LAVERSTOCK & FORD PARISH COUNCIL

Report for Agenda Item 21.024

Subject: Local Plan Consultation Joint Responses
Date: 12th February 2021
Author: Trudi Deane, Deputy Clerk.

Salisbury Consultation Response Form

Slide from Public Consultation Presentation showing location of Site 1

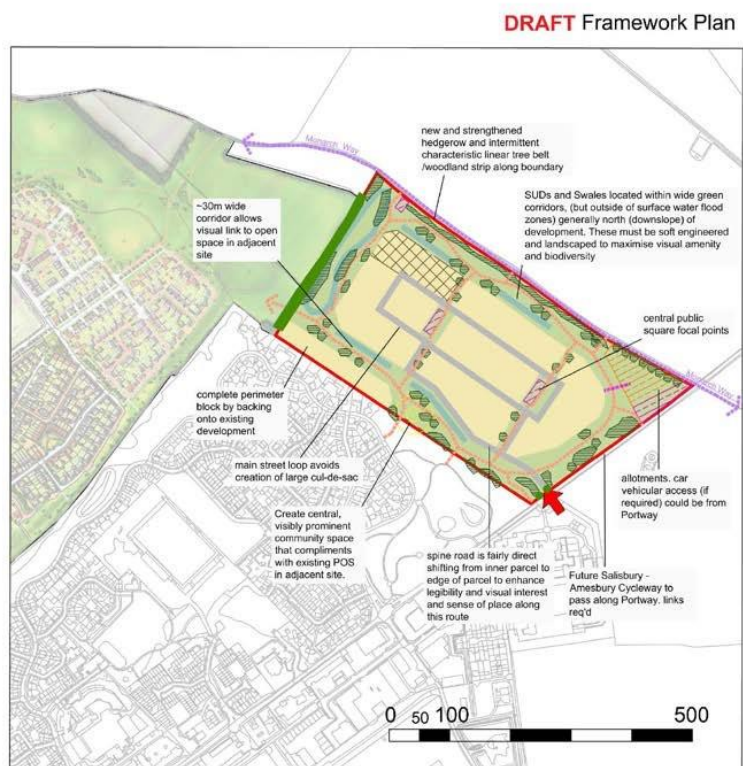
Site 1 lies at the very northern edge of our parish and the greater Salisbury area. It lies just over a slight ridge as you approach Old Sarum along the Portway from the north east. At the moment Old Sarum is hidden by the ridge so the approach along the Portway by car is in a rural setting until the ridge is crossed. The transition into the built environment is then currently softened by the country park with its recently planted trees, which lies in front of the existing housing to the right and there is Throgmorton Hall with its surrounding mature trees to the left. If Site 1 is built on it appears likely to be seen over the ridge on the approach along the Portway. The height and positioning of houses and any screening planting will need to be carefully planned and modelled to ensure that the approach views are not spoiled. Similarly, care will need to be taken with the first view of the built environment to maintain the current soft transition, by providing a green buffer between the road and the housing, as described above. A further concern is that the Monarch's Way long distance national footpath runs on the ridge along the north east boundary of the site. This is also identified as a key green corridor in the Green Blue Infrastructure mapping on p23 of the Planning for Salisbury Local Plan paper. The adjoining Longhedge Village to the north west has a country park in the equivalent field to Site 1 separating the housing from the Monarch's Way and forming part of this green corridor. Development of this site will bring housing much closer to the Monarch's Way and cause a blockage to the green corridor. Great care will be needed to maintain the rural feel of the footpath and avoid significant biodiversity harm (even before providing the 10% net gain requirement). A WW2 pill box is situated on the site adjacent to the Portway. This would need to be preserved, together with its context, in any development.

Finally, parts of this site are visible from Old Sarum scheduled monument and, due to the elevation of the field rising away from the monument the roofs of any houses will be higher than the current roof line. Again, scale of development, roof heights and mitigation will require careful thought and questioning of whether the site can support 275 houses without excessive impact. The concept plans do not appear to adequately address any of these issues.

The concept plans are very simplistic. Much more detail is required to judge the actual landscape visual impact, biodiversity impact, etc., but since they are part of a document setting out the proposed spatial strategy for the next 15 years effort in this direction is probably inappropriate as much can change in that timeframe. What is required is consultation on detailed plans in the year or so before sites are considered for planning permission. Responses at this stage need to help formulate the constraints within which the scheme needs to be developed. These constraints should include, but not be limited to:

- Housing set back from the Portway in a similar way to the current Old Sarum north east boundary
- Reducing housing density and height, preferably to single storey, across the development towards the Monarch's Way
- Adequate green space and planting adjacent to the Monarchs Way to provide visual screening and suitable habitat for its green corridor status.
